Subject: AP1000 Response to Request for Additional Information (SRP 3)

Response to Request for Additional Information on SRP Section 3

RAI Response Number: RAI-SRP3.7.1-SEB1-06
Revision: 5

RAI Response Number: RAI-SRP3.7.1-SEB1-17

Figure RAI-SRP3.7.1-SEB1-06-1: X-Direction Comparison

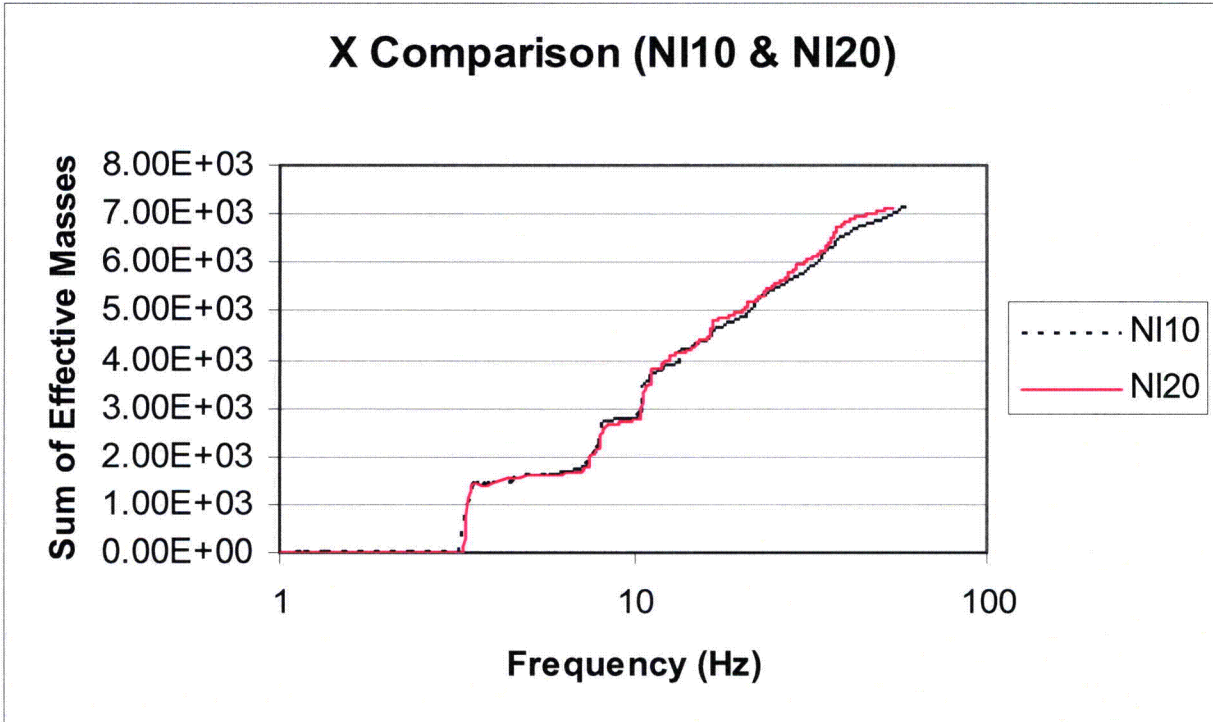
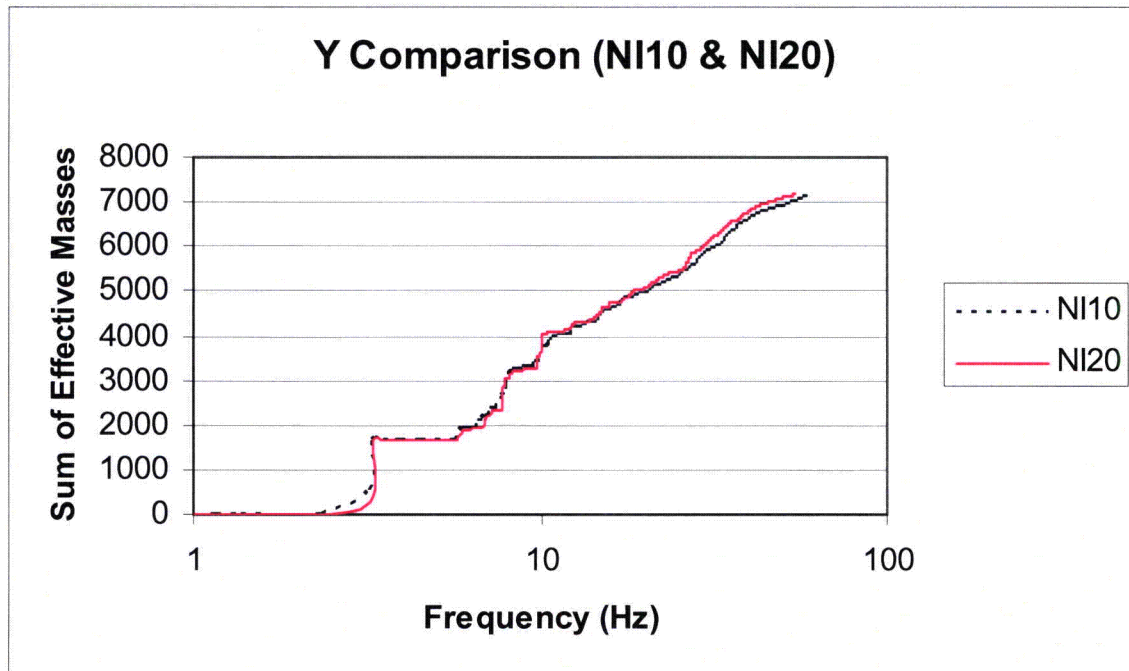
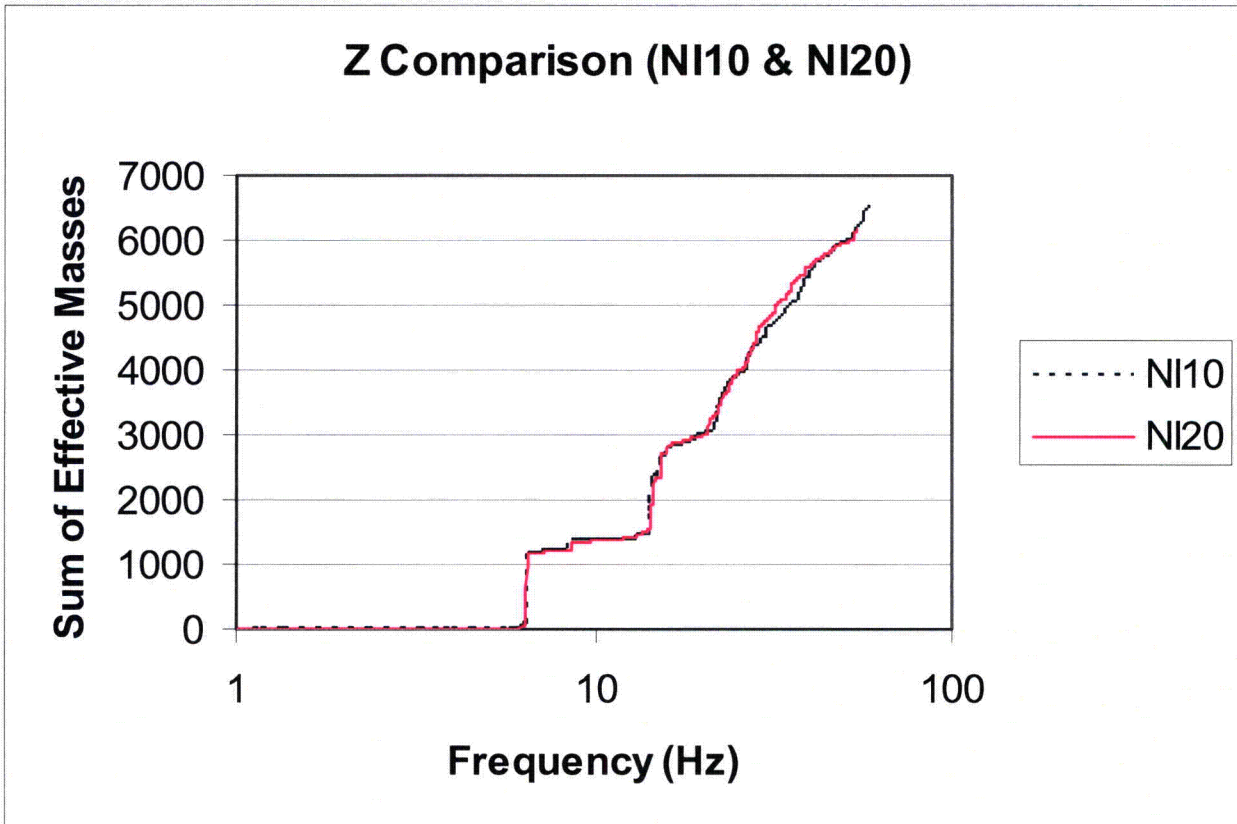
- (a) In the 0-10 Hz range, there are 58 modes for NI20 and 69 modes for NI10. In the low frequency range, the correlation would be expected to be near 100%.
- (b) In the 10-40 Hz range, the difference in number of modes is very large: 658 for NI20; 1234 for NI10.
- (c) In the 40-55 Hz range, the difference in number of modes is relatively small: 484 for NI20; 545 for NI10.

Figures RAI-SRP3.7.1-SEB1-06-1 to RAI-SRP3.7.1-SEB1-06-3 show a summation of the of the effective mass versus frequency for the X, Y and Z directions. The effective masses associated with the NI20 and NI10 models compare closely over the frequency range of 1 to 80 Hz.

The difference in the number of modes between the NI10 and NI20 models is due to the increased number of degrees of freedom in the NI10 model. Therefore, it is expected that the NI10 model will have more modes within given frequency ranges. It is not possible to easily provide direct comparisons of the mode shapes between the two shell models because of their complexities and size. The best demonstration that the models are responding in a similar manner is by the comparison of modal mass over the frequency range of interest. This comparison has been provided in Figures RAI-SRP3.7.1-SEB1-06-1 to RAI-SRP3.7.1-SEB1-06-3. As seen from the comparison plots the modal response is the same in both models demonstrating the modal response will be similar.

Figure RAI-SRP3.7.1-SEB1-06-04: HRHF Acceleration Response Spectra

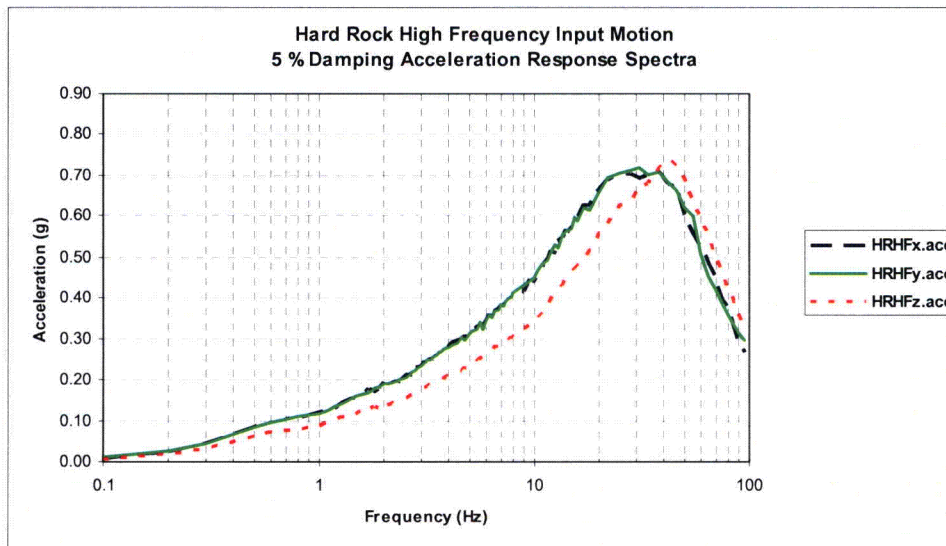
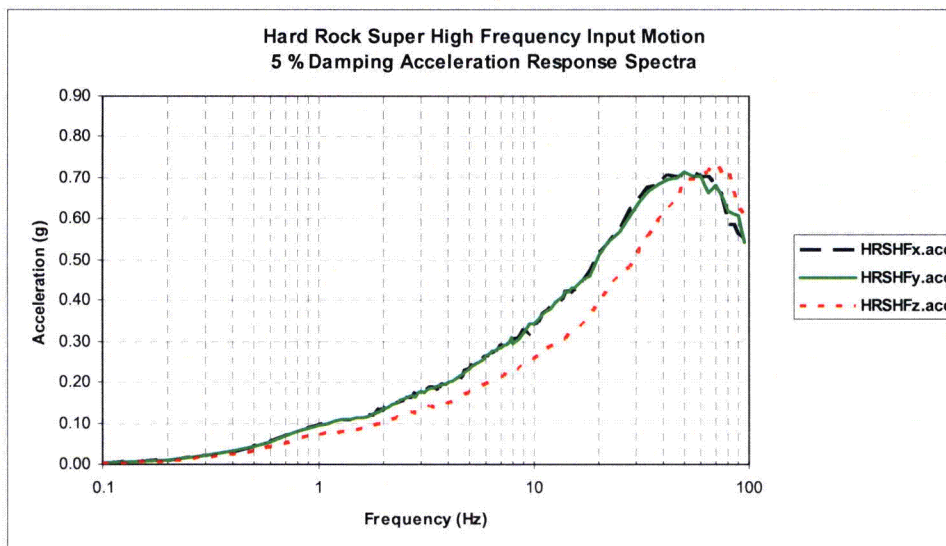
Please provide more detail.

The HRHF spectra peaks at about 25 Hz. In order to confirm the NI20 model’s adequacy for frequencies up to 50 Hz, a time history analysis was performed in ANSYS using the NI20 and NI10 models with the Westinghouse defined Hard Rock High Frequency (HRHF) input time history. The time step for the HRHF time history was changed from 0.005 to 0.003 seconds. This shifts the peak of the input time history to 50 Hz while maintaining the statistically

indeterminate properties of the original HRHF spectra defined in TR115. We shall refer to this as the Hard Rock Super High Frequency (HRSHF) analysis in subsequent discussions. The HRHF and HRSHF acceleration response spectra have been provided in Figures RAI-SRP3.7.1-SEB1-06-04 and RAI-SRP3.7.1-SEB1-06-05 to show the acceleration peak shift due to the time step change.

Figure RAI-SRP3.7.1-06-6: Wall 2 Response Spectra at Node 20426 Compared to Group Design FRS at Elevation 135 ft

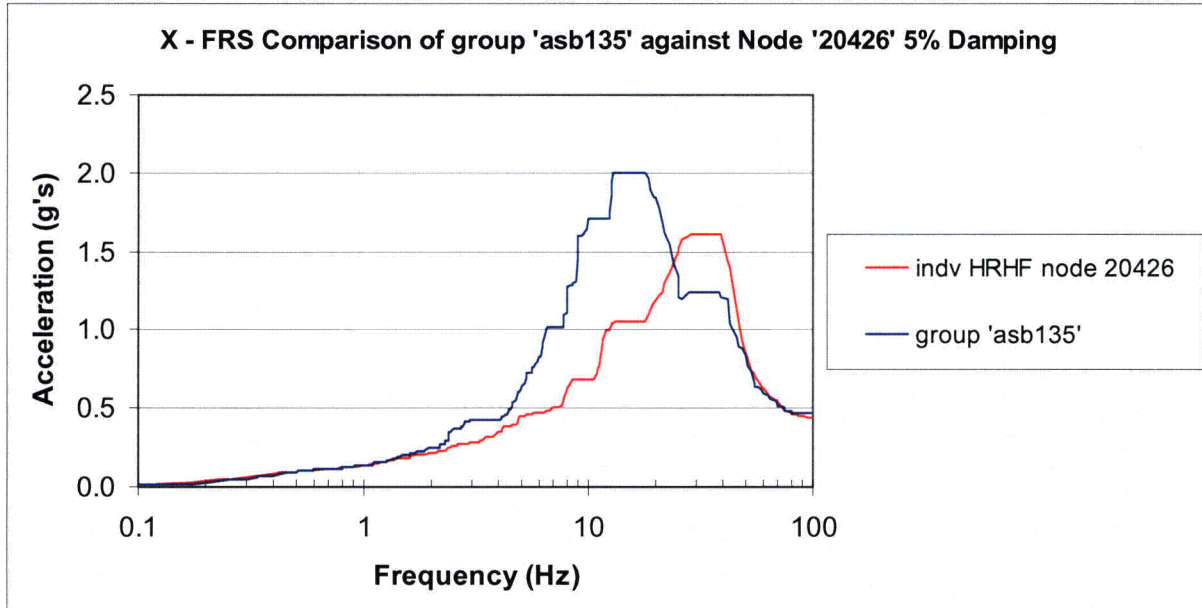
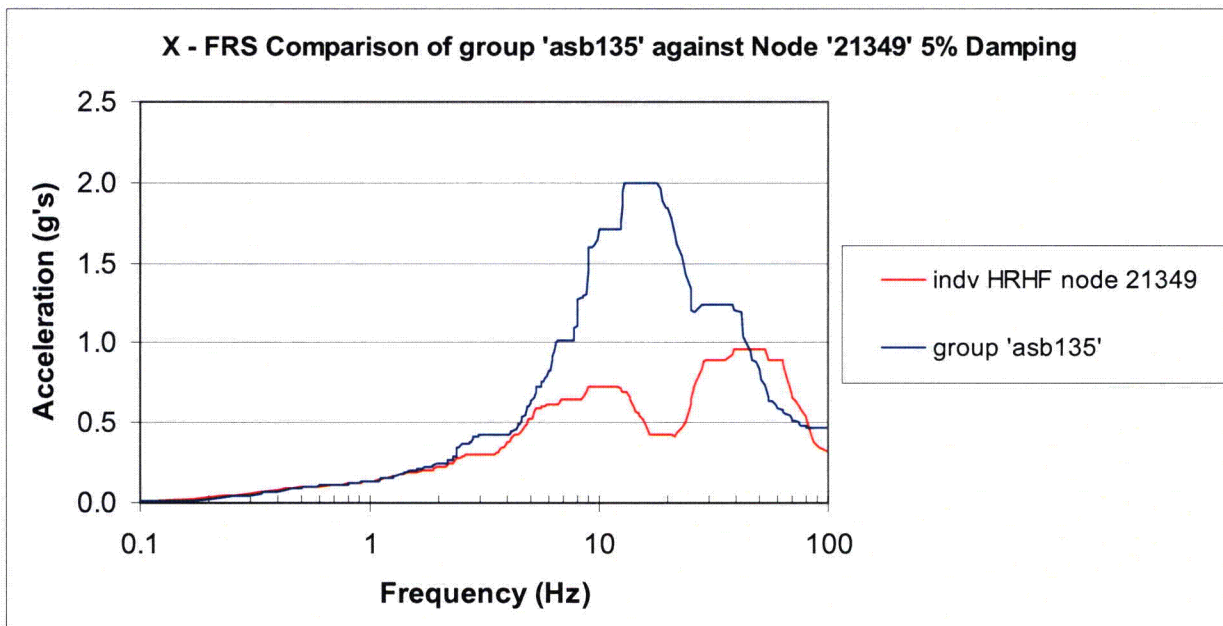
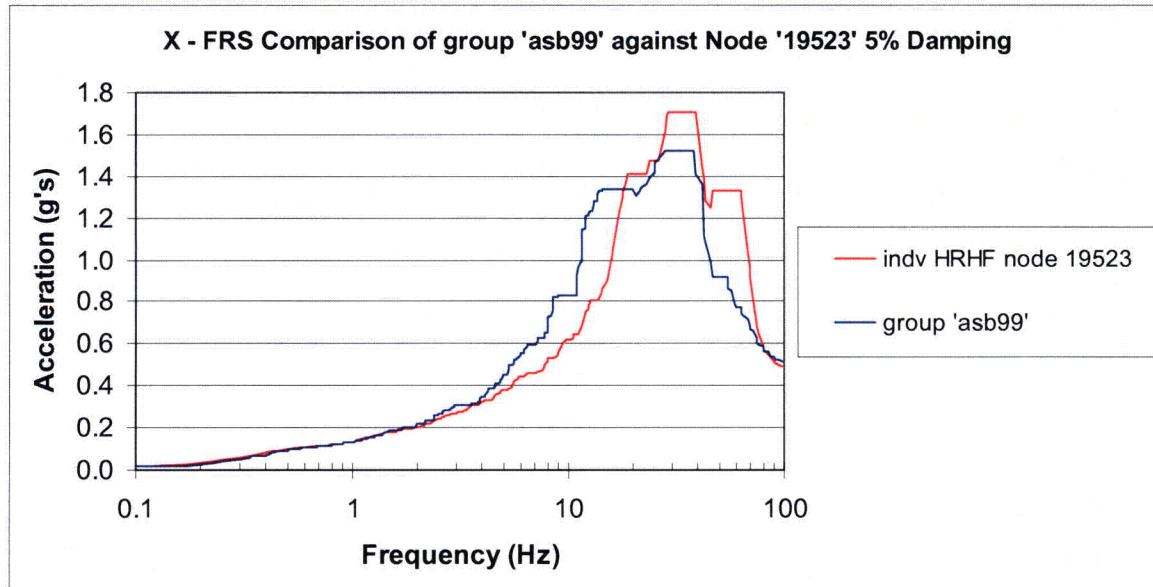
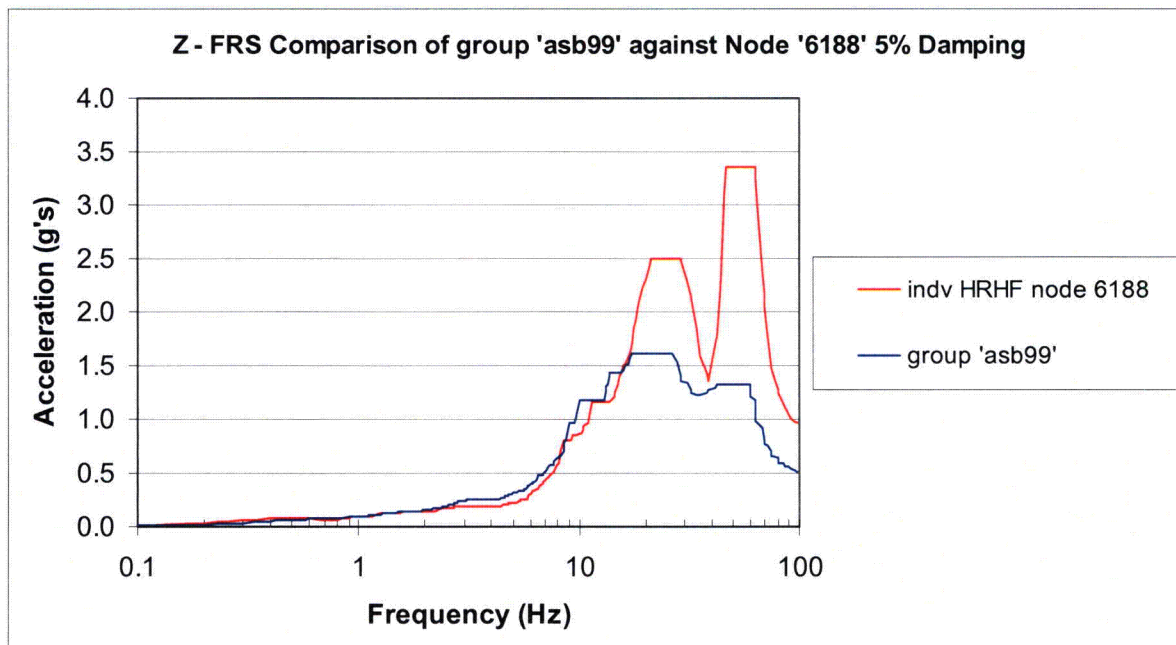
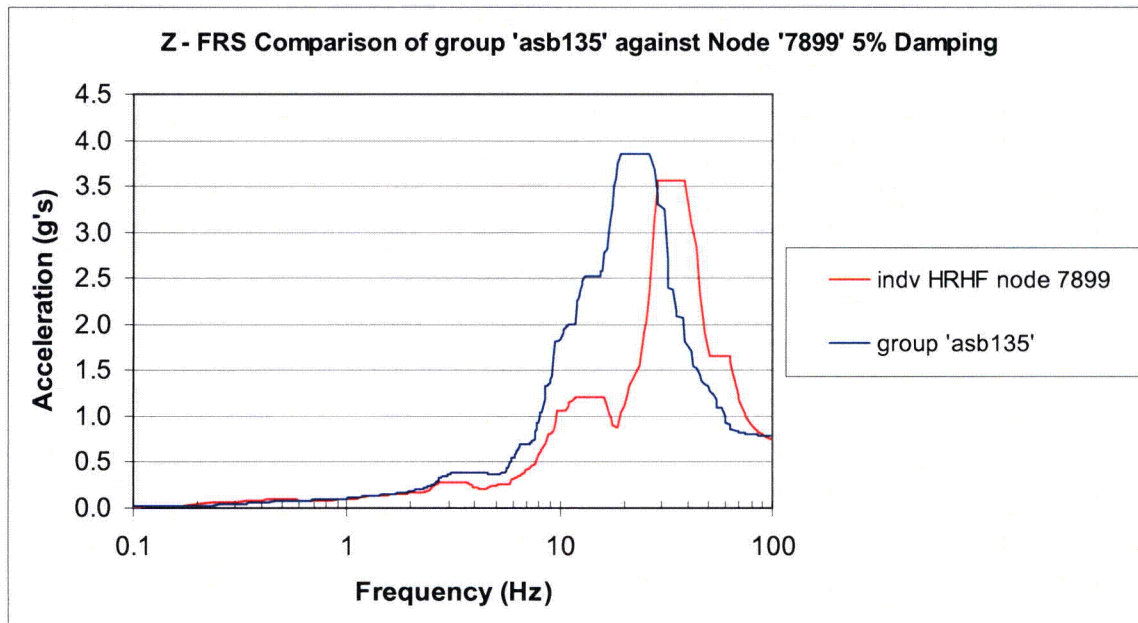
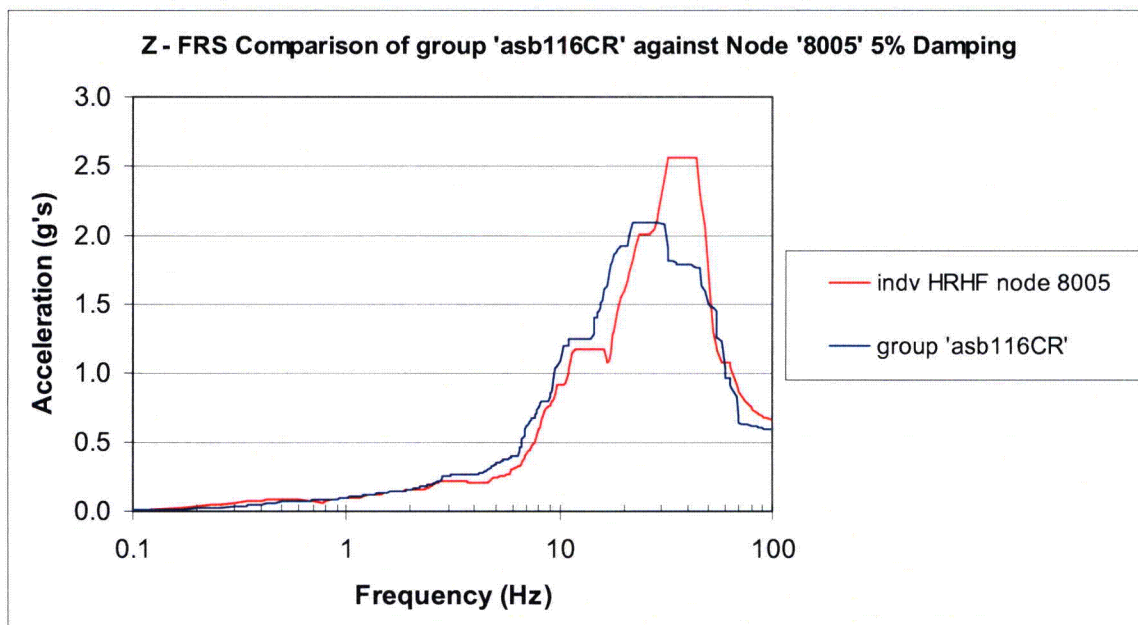
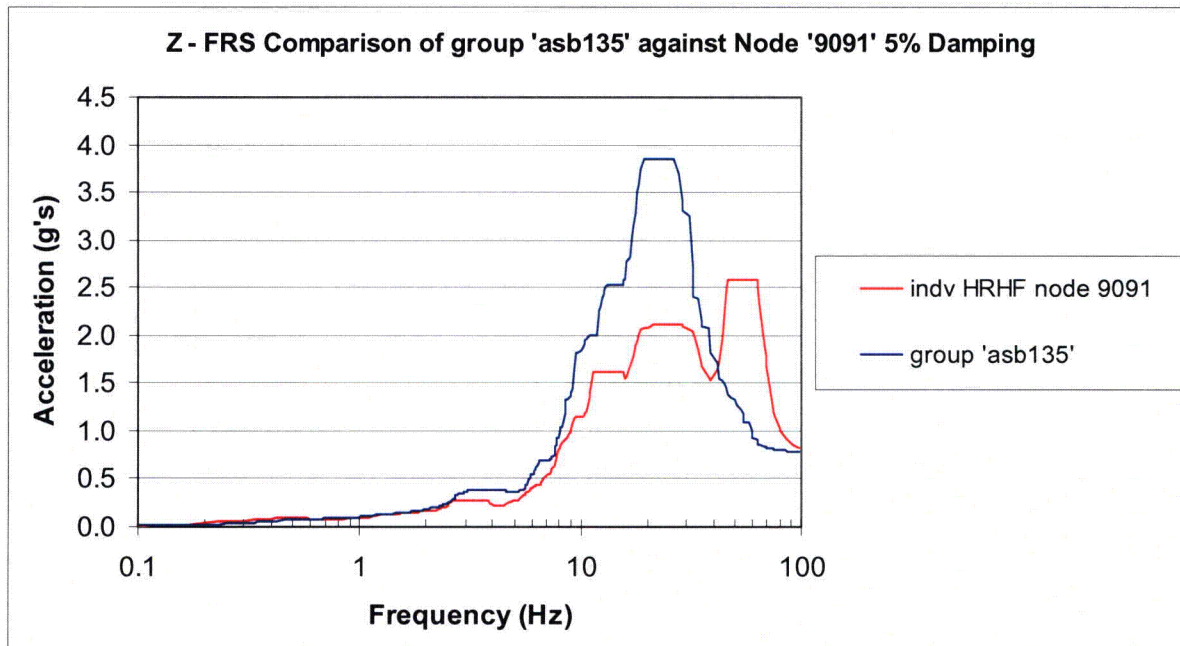
- (a) A list of flexible regions (<50 Hz) identified in the NI05 model that are not represented in the NI20 model.
- (b) A representative sample of ISRS comparisons, at locations where the NI05 results exceed the NI20 results.
- (c) A summary discussion of the effect of the additional local amplification on the structures, piping, and equipment sampling assessments.

The response spectra comparisons for the 7 additional NI05 flexible nodes against the design "groups" at the same elevation are shown in Figures RAI-SRP3.7.1-06-6 to Figures RAI-SRP3.7.1-06-12 (out-of-plane direction only). Each of the spectra in Figures RAI-SRP3.7.1-06-4 through RAI-SRP3.7.1-06-10 shows amplification beyond the "group" spectra for the NI20 HRHF time history analysis.
